Section 16 Planning Application for Proposed Mixed-Use Development (Proposed Flat with Permitted Commercial Uses) with Minor Relaxation of Building Height Restriction at Lot 4354 in D.D. 124, Kiu Tau Wai, Yuen Long (Application No. A/HSK/617)

Response to Departmental Comments

SHEET NUMBER
60640967/SIA/FIGURE 4

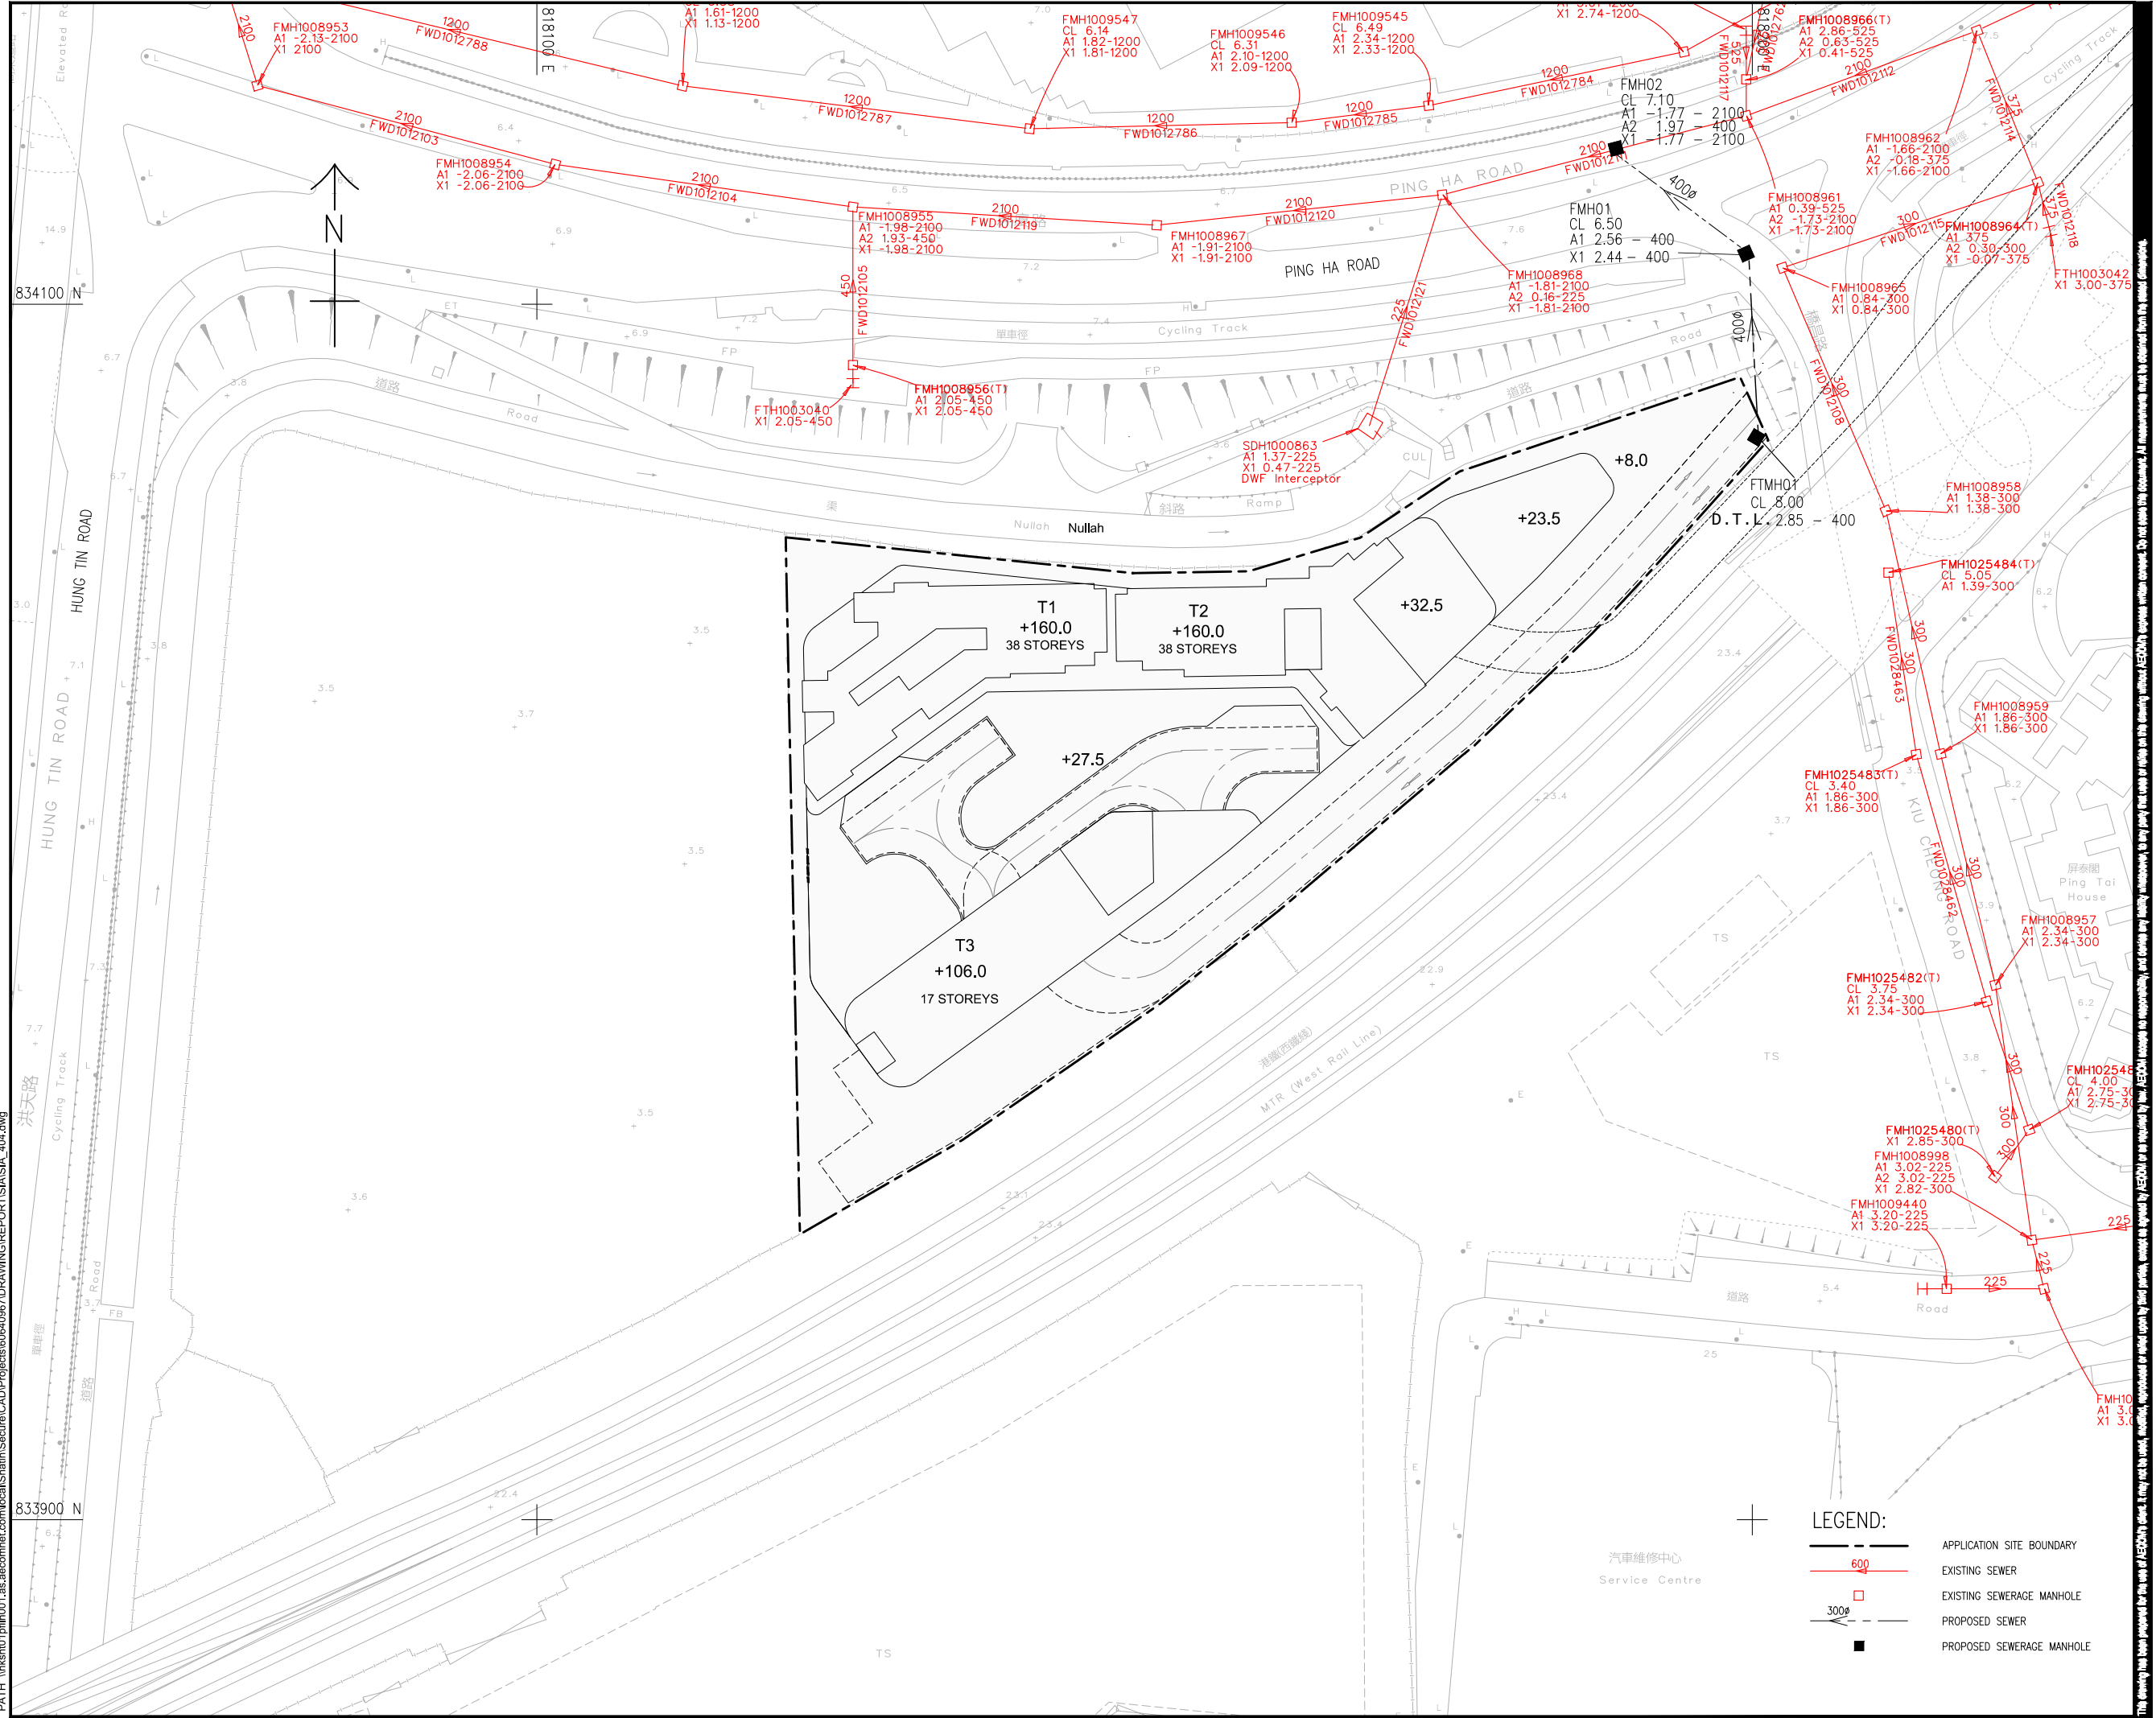
3.10	The cover level of the proposed upstream manhole should be higher than that of the downstream manholes. Please review the cover level and alignment.	Noted. The cover levels of the proposed manholes will match the finished ground levels. The invert levels of the proposed upstream pipe have been designed higher than the downstream inverts. Please refer to the updated Figures 4 and 5 of the SIA replacement pages under Attachment 6 for the specific pipe inverts.

3.12	Please provide the connection details at the discharge point and indicate relevant details (e.g., cover level, invert level, and D.T.L.) on the drawing.	A new manhole FMH02 will be constructed between existing manholes FMH1008961 and FMH1008968 for the new 400mm sewer to discharge at slightly higher level. Please refer to the updated Figures 4 and 5 of the SIA replacement pages under Attachment 6 .

60640967/WSIA/FIGURE 7

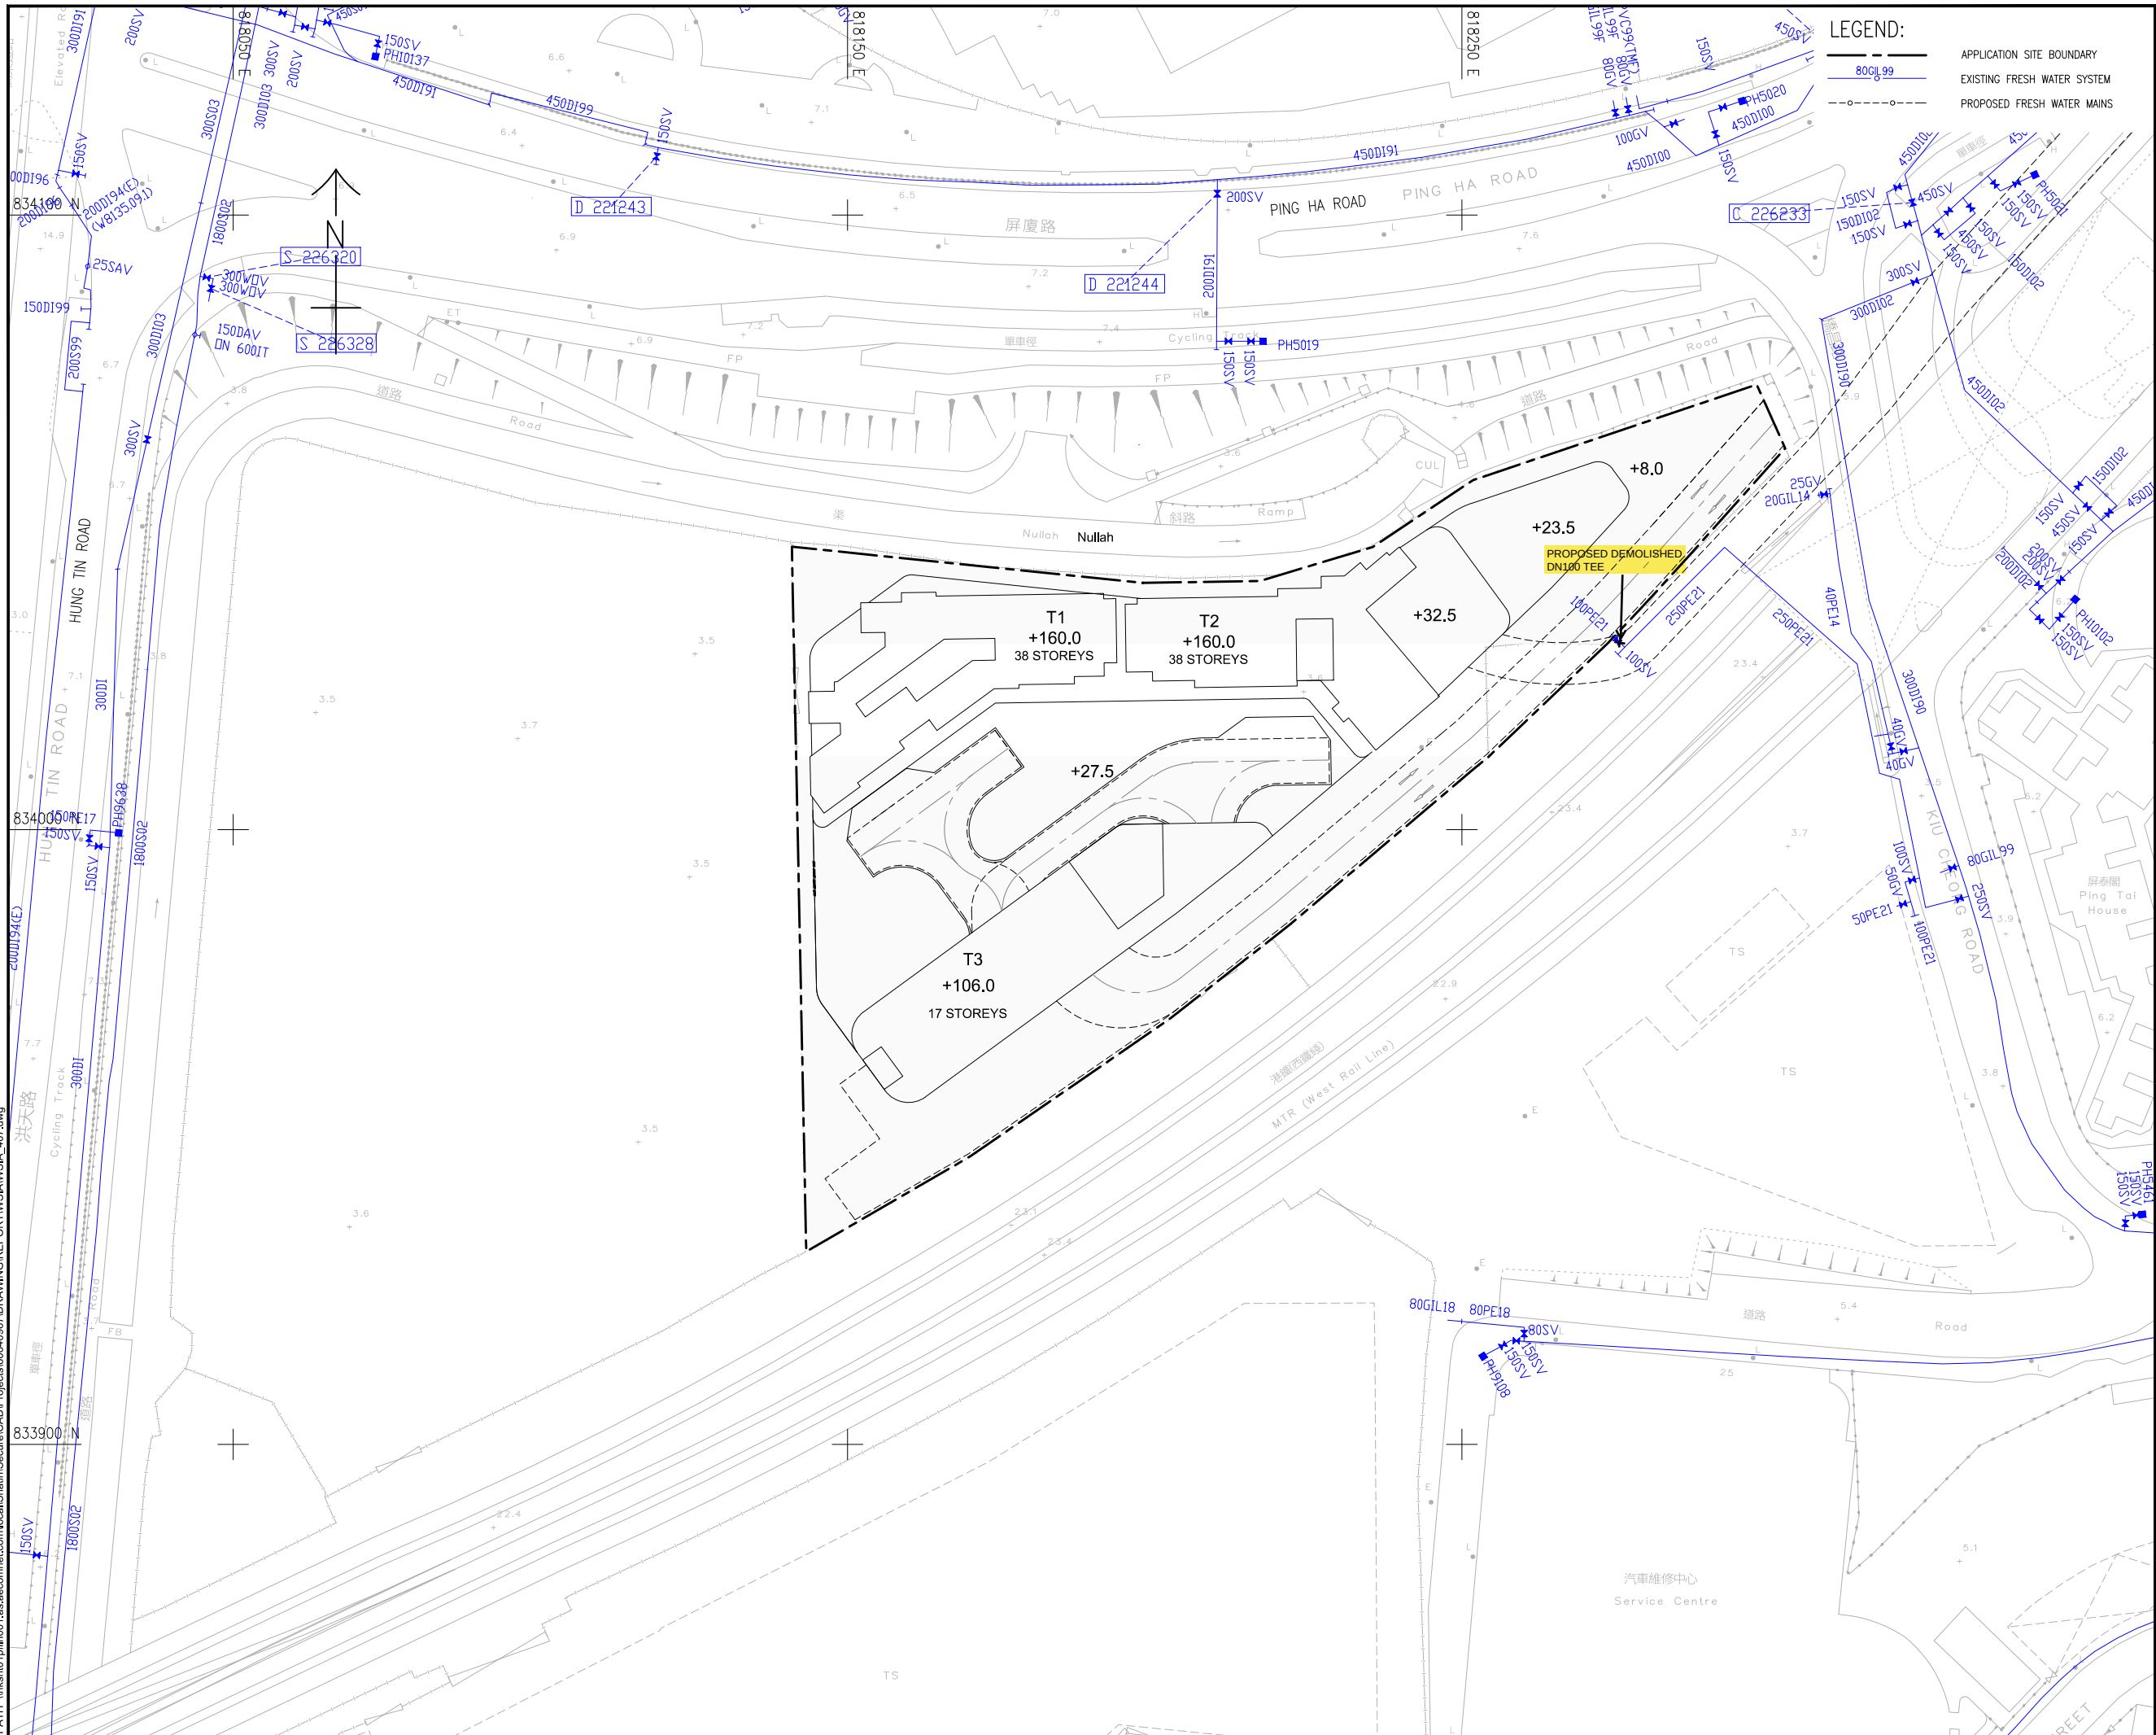
9.2	Drawing No. 50540967/WSIA/FIGURE 7: For clarity, please remove the proposed fish water lead-in pipes within your site or boundary.	Noted. The proposed freshwater lead-in pipes have been removed in Figure 7 of the WSIA replacement pages under Attachment 7 for clarity.
